STAFF REPORT
BOARD OF ADJUSTMENT
For the April 20,2016 meeting

TO: Board of Adjustment members
FROM: Sheena Nuetzman, Planning Director
SUBJECT: Conditional Use Permit for Quik Trip Corporation- 63rd Street and Hickman Road

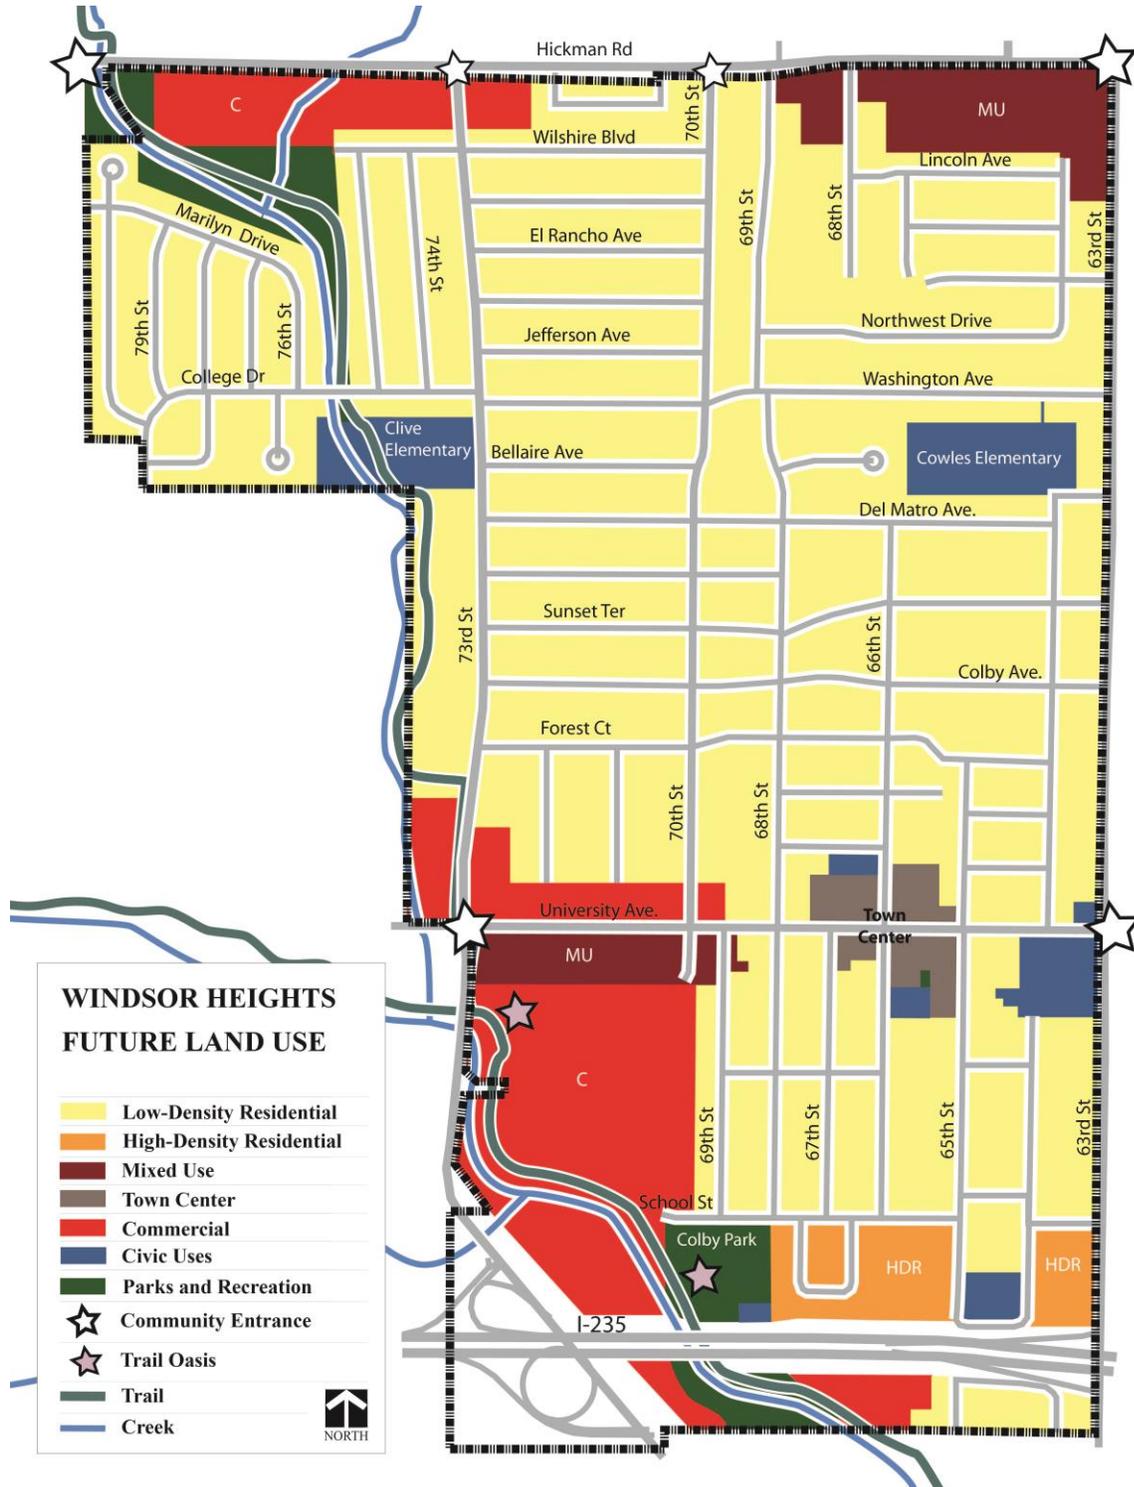
Parking and Internal Circulation	All structures must be accessible to public safety vehicles.	
Parking and Internal Circulation	Development must have access to adjacent public streets and ways. Internal circulation should minimize conflicts and congestion at public access points.	
Landscaping	Landscaping should be integral to the development, providing street landscaping, breaks in uninterrupted paved areas, and buffering where required by surrounding land uses. Parts of site with sensitive environmental features or natural drainage ways should be preserved.	<p>Staff comments: <i>Barberry thunbergii</i> is a proposed landscaping material but is prohibited per the Hickman Overlay standards.</p> <p>Quik Trip response: The <i>Barberry thunbergii</i> has been removed and replaced with shrub rose as is planted at the Quik Trip at 73rd St. and Hickman Road.</p> <p>Staff comments: The City right-of-way trees planted last fall needs to be indicated on the site plan to ensure proposed landscaping will not impede with trees already planted.</p> <p>Quik Trip response: The City planted trees have been added to the site plan.</p> <p>Staff comments: A buffer yard must be provided to visually screen the rear elevations of the building and parking areas.</p>

<p>Quik Trip response: Approximately 85 linear feet of Quik Trip’s property boundary adjoins R-3 lots Existing, mature vegetation along with the proposed elevation change from the south property boundary line to the southern curb and gutter line should provide a sufficient buffer. Therefore, we believe an opaque barrier is not warranted.</p>
Building Design	<p>Architectural design and building materials should be compatible with surrounding areas or highly visible locations</p>	<p>Staff comments: Staff has asked that the applicant respond to how the building design is compatible with the overall theme and uniqueness of the rest of the development in the area.</p> <p>Quik Trip response: The building is comprised of structural brick with a high amount of architectural features that will compliment any other development that were to develop adjacent to us.</p> <p>Staff comments: The rear elevation of the proposed building provides the continuation of brick, but does not provide the same level of cornice detail as the other sides of the building.</p> <p>Quik Trip response: We will add rear pilasters and internal roof drains that will carry the architectural theme around the rear façade.</p>
